Millstone Nuclear Power Station, Unit No. 1
Provisional Operating License No. DPR-21
Reload #6 License Amendment Submittal

DESCRIPTION OF
TECHNICAL SPECIFICATION CHANGES

PROPOSED TECHNICAL SPECIFICATION CHANGES

MILLSTONE 1, RELOAD 6

Figure 3.11.1h MAXIMUM AVERAGE PLANAR LINEAR HEAT GENERATION RATE (MAPLHGR) VS. PLANAR AVERAGE EXPOSURE, RELOAD 6 (8DRB265H and 8DRB265L)

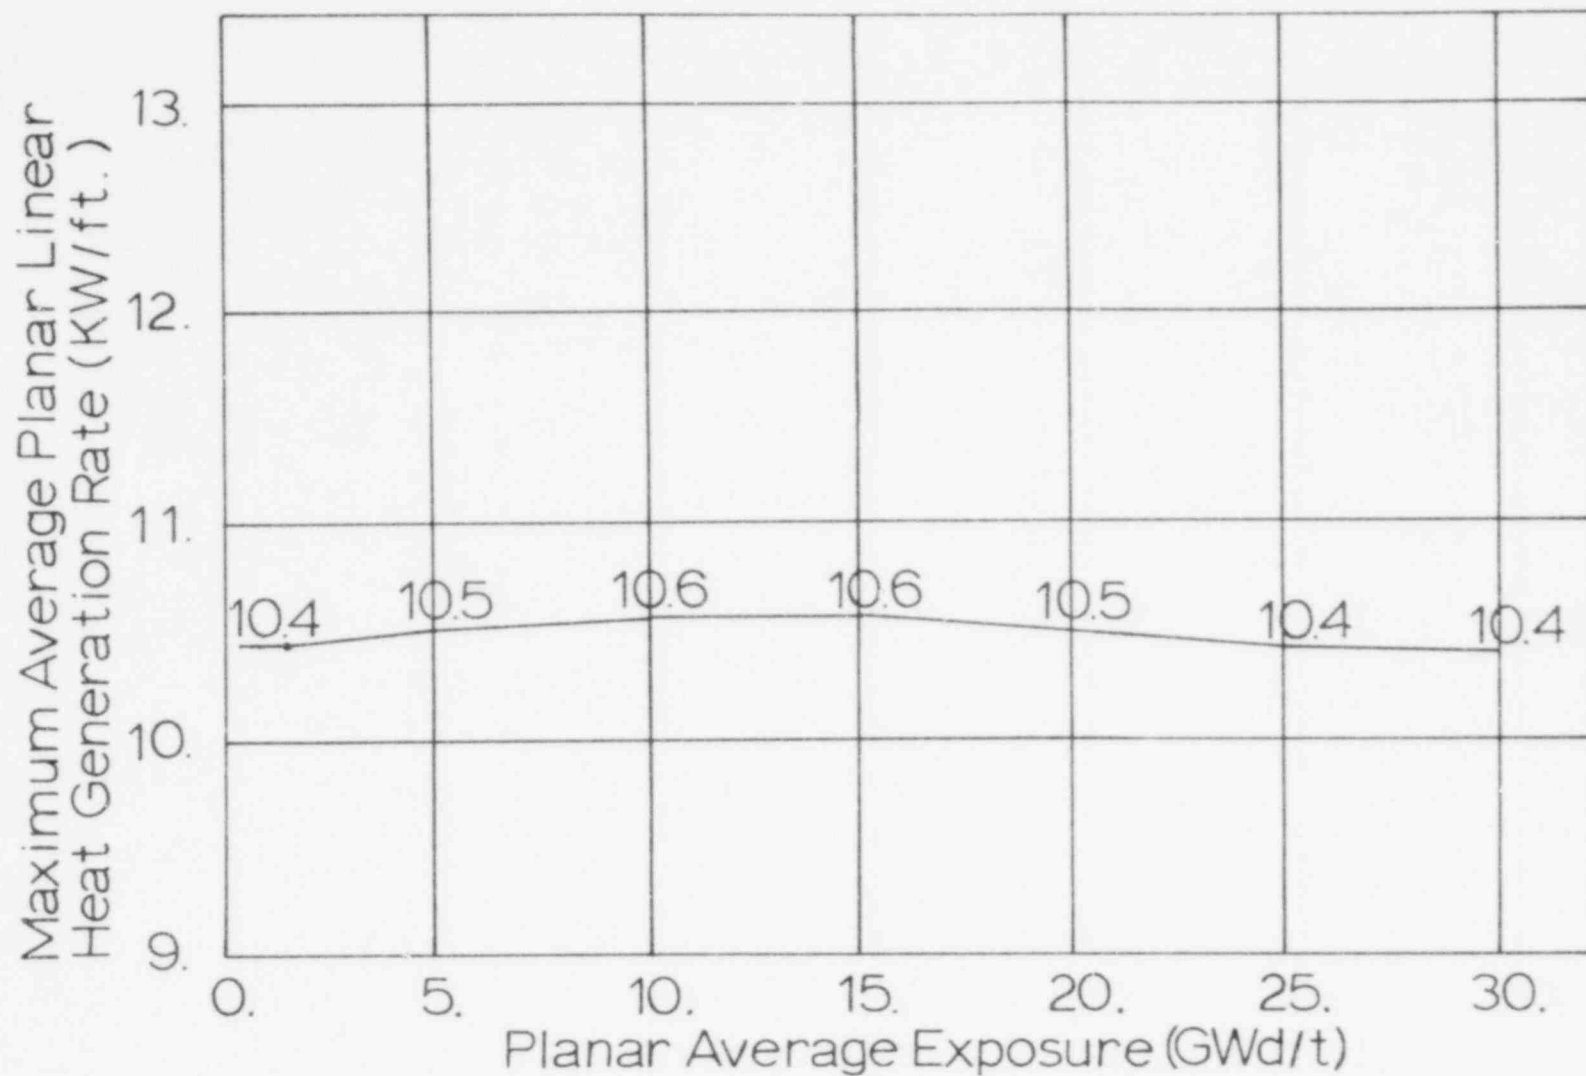
Maximum Average Planar Linear Heat Generation Rate and Minimum Critical Power Ratios,

<u>Section</u>	<u>Page</u>
Figure 3.11.1h	3/4 11-7b
Table 3.11.1	3/4 11-10
Bases 2.1.1	B2-1, B2-2
Bases 2.1.2A, B, E, F	B2-6, B2-7, B2-8
Bases 3.2	B3/4 2-3

The revised operating limit MAPLHGR's and CPR's are the result of transient analysis performed with the Cycle 7 core. The limits are supported by the attached topical reports NEDO-24168 and NEDO-24168-1, Supplemental Reload Licensing Submittals for Millstone 1, Reload 6.
